CITY OF PROVIDENCE, RHODE ISLAND

RFP Title: Site Improvements at Hopkins Sq. Park

Addendum #: 2

Issuing Date: 12 Aug 2026

**10 6" CONCRETE PAVING**  
NTS

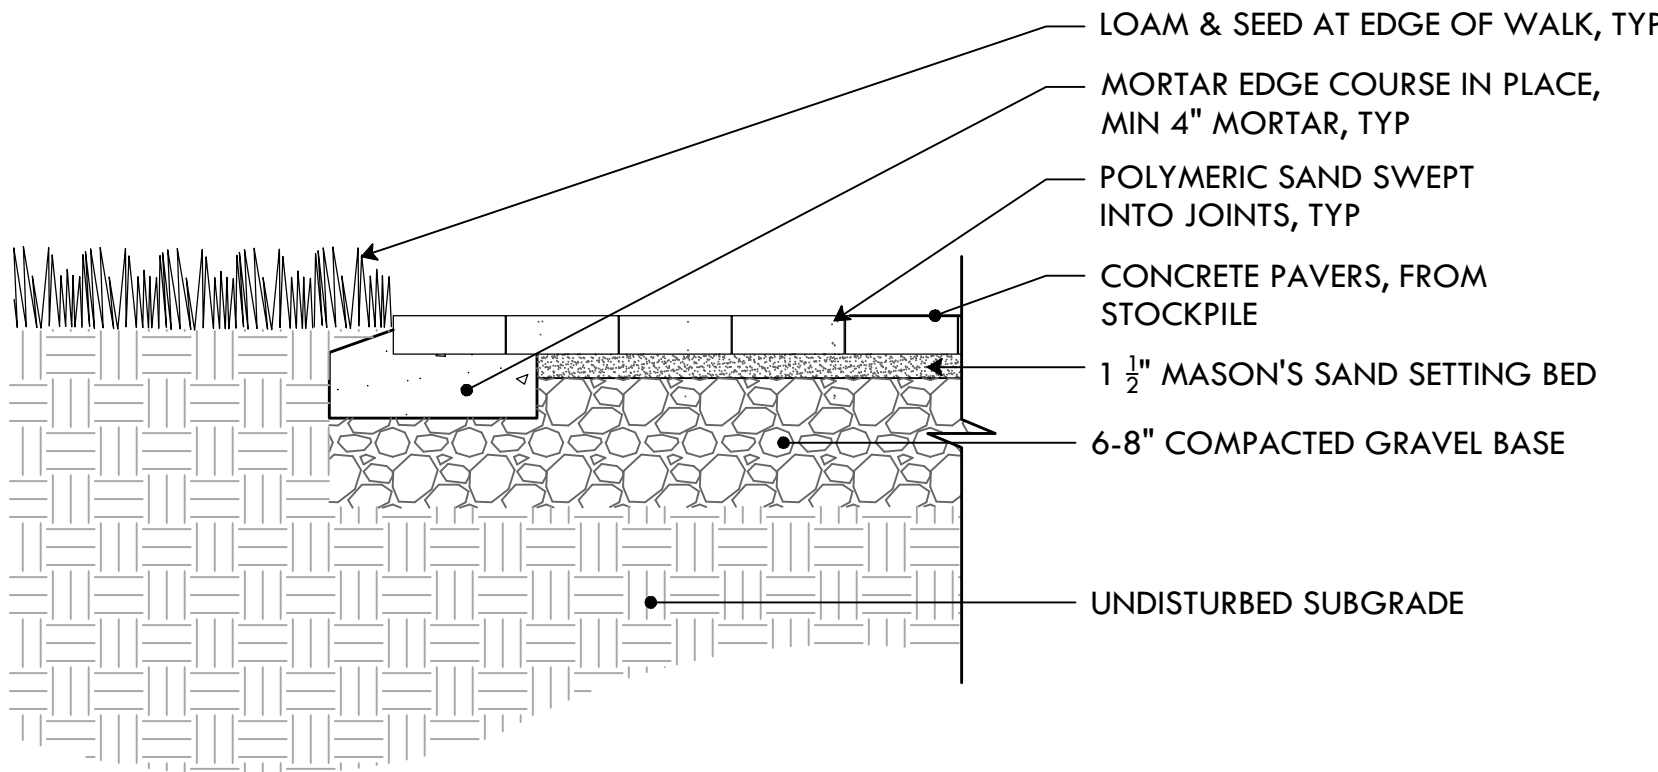
1. Addendum 2 provides additional specificity to Add/Alt #1 and introduces Add/Alts #2 and #3.
2. Other additions include modifications to the paths, as well as new construction details.
3. Q: "I have a question regarding the RFP Title: Site Improvements at Hopkins Sq. Park.
